AREVA NP RESPONSE to FOURTH REQUEST FOR ADDITIONAL INFORMATION (RAI)

ANP-10272, "SOFTWARE PROGRAM MANUAL FOR TELEPERM XS™ SAFETY SYSTEMS  
TOPICAL REPORT" (TAC NO. MD3971) PROJECT NUMBER 733

**Figure 71-1 – Test Document Work Flow and Control Points**

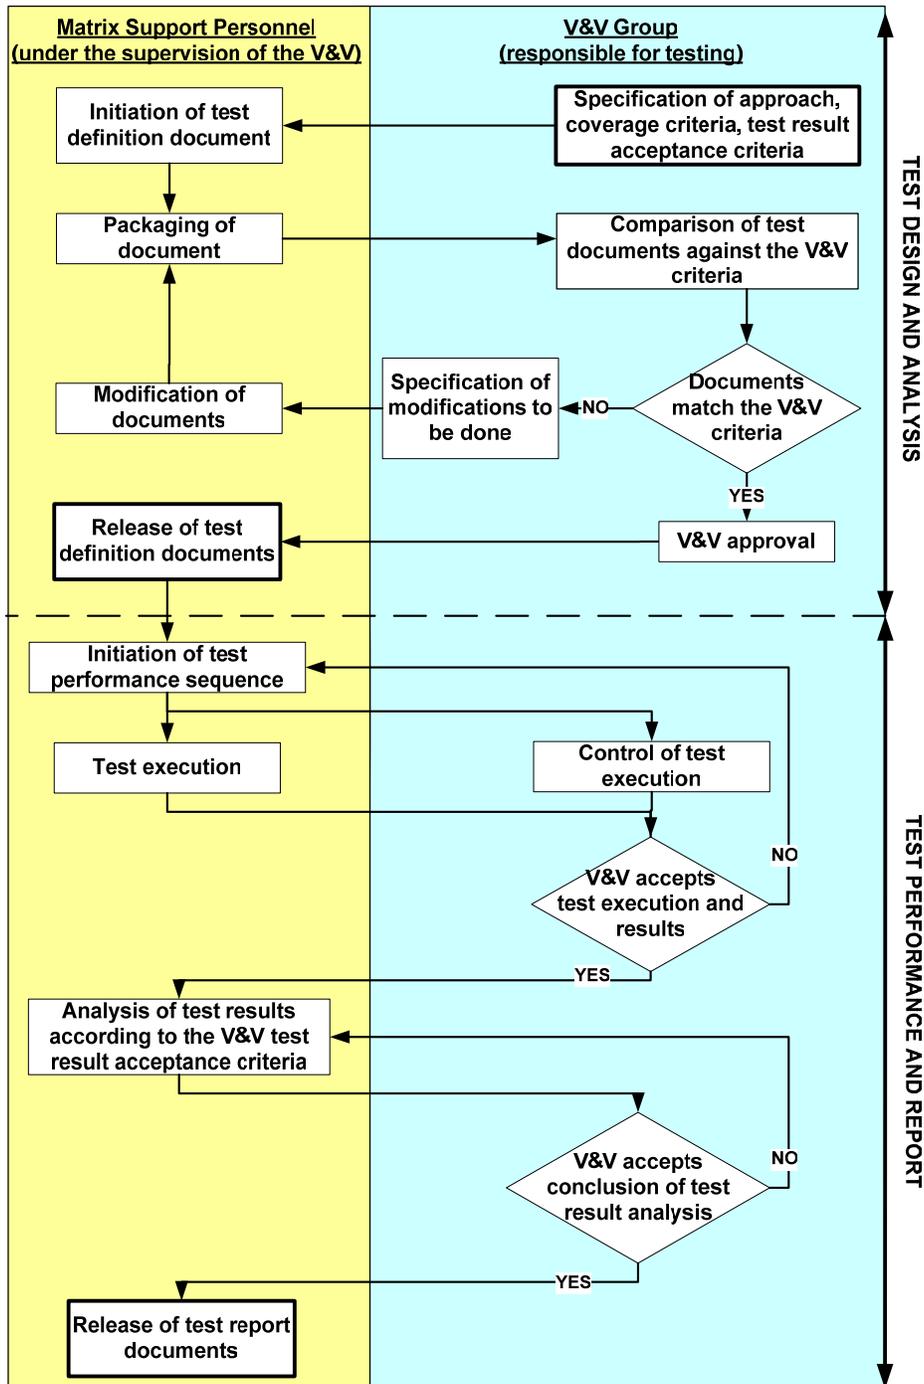
**RAI-71 Question:** What is AREVA NP's justification for deviating from IEEE 1012-1998 in allowing the software design organization to design and run verification and validation (V&V) tests in place of the V&V organization?

**NRC Concern:** The V&V organization exists as a separate check and balance to the design engineering and software organizations to provide a high degree of confidence in the compliance with functional, performance, and interface requirements; and in the completeness and correctness of the software or system in question. The V&V team, in some ways, may be viewed as a layer of diversity and defense-in-depth in the quality, design, and testing processes.

Allowing the software design organization to design and run V&V tests in place of the V&V organization indicates a loss of that diverse defensive layer in a safety-critical stage of software testing. Various errors of interpretation and implementation which may have been introduced into the software by the thinking of the software design organization will likely be masked in the design and execution of the V&V tests through those same pathways of interpretation if executed by the same organization. AREVA NP has not explained or justified how its procedures and methods will mitigate these possible errors in lieu of fully complying with IEEE 1012 (by maintaining the V&V organization's complete responsibility for the design and execution of V&V tests). It has also not detailed any specific requirements of the V&V organization in this scenario.

The staff requires additional information to determine if the proposed alternative to the requirements of IEEE 1012 will provide an equivalent confidence in a high quality test process, and therefore an equivalent confidence in the safety of the resultant system.

The Software Verification and Validation Plan (SVVP) conforms to the guidance of the applicable recommendations of IEEE Std 1012-1998, as endorsed by Regulatory Guide 1.168, Revision 1. One area of exception with regard to the IEEE Std 1012-1998 is the use of matrixed support personnel from the development groups to perform some of the validation test activities. The Verification and Validation (V&V) group may get assistance from the Software Design group, Hardware Design group, and the Test group for the preparation of validation test specifications, procedures, and reports and the performance of test tasks; however, these support personnel shall work under the supervision of the V&V group. These support personnel may not develop software test documents for design work they prepared. These matrixed personnel bring special skills to supplement the validation activities. This testing method ensures that the proper hardware and software personnel are used in an integrated fashion to develop and conduct the system tests, including the Factory Acceptance Test (FAT). The test document workflow and control points are shown in Figure 71-1 to ensure that the independence of validation testing is maintained.

The system test, including FAT, is performed under the direction of the Verification and Validation group. The system test plans, specifications, procedures, and reports are prepared in accordance with the Software Verification and Validation Plan and 10 CFR Part 50 Appendix B QA requirements.

The Software Program Manual will be revised to incorporate this information.

**Figure 2.2 from TXS Topical Report**

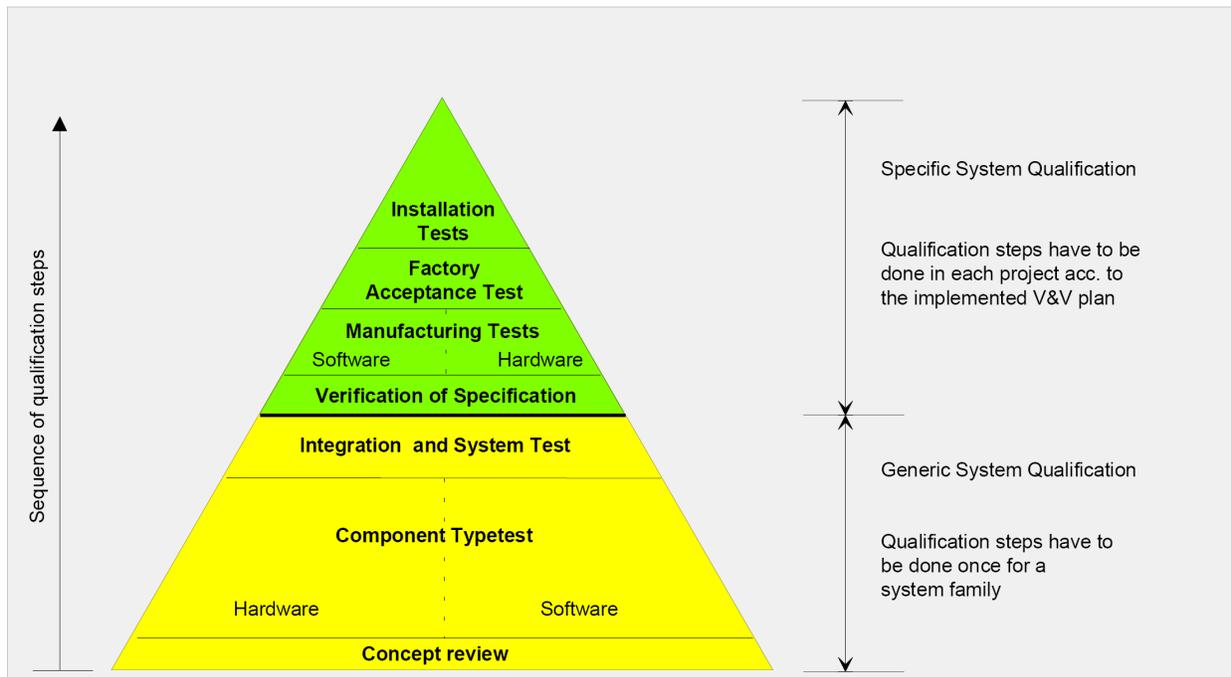
**RAI-73 Question:** What is AREVA NP's justification for crediting SIVAT testing in reducing the scope of the factory acceptance test (FAT) and other unit and integration testing?

In general, there is no way for the NRC to understand what is meant by a reduction in FAT testing with the information currently provided by AREVA NP. It appears that SIVAT simulates the software's operation. With the use of SIVAT, AREVA NP needs to demonstrate how FAT will fully verify and validate software/hardware integration aspects. AREVA NP should provide procedures and processes that will ensure software/hardware integration aspects are appropriately addressed in the proposed V&V scheme.

It should also be understood that SIVAT is not an approved tool. While the concept of simulated testing was mentioned briefly in the TELEPERM XS topical report, the SIVAT tool was not described, nor was it approved by the associated SER. As such is the case, a reference to the TELEPERM XS topical or SER is not considered sufficient justification or explanation for the SIVAT, FAT, unit, and integration testing proposed by the SPM.

The overall qualification process for the TXS system is shown in Figure 2.2 from the TXS Topical Report. The qualification process is a two-part process: generic system qualification and specific system qualification. The qualification process for application software starts with the application-independent (generic) qualification process described in Section 2.1. The generic qualification process included an integration and system test phase. The specific system used for this generic qualification step is described in detail in Section 3.2.2 of the TXS Topical Report.

The overall application independent qualification process is described in Section 2.2 of the TXS Topical Report. The TXS platform qualification process is shown below (reproduction of TXS Topical Report Figure 2.2).
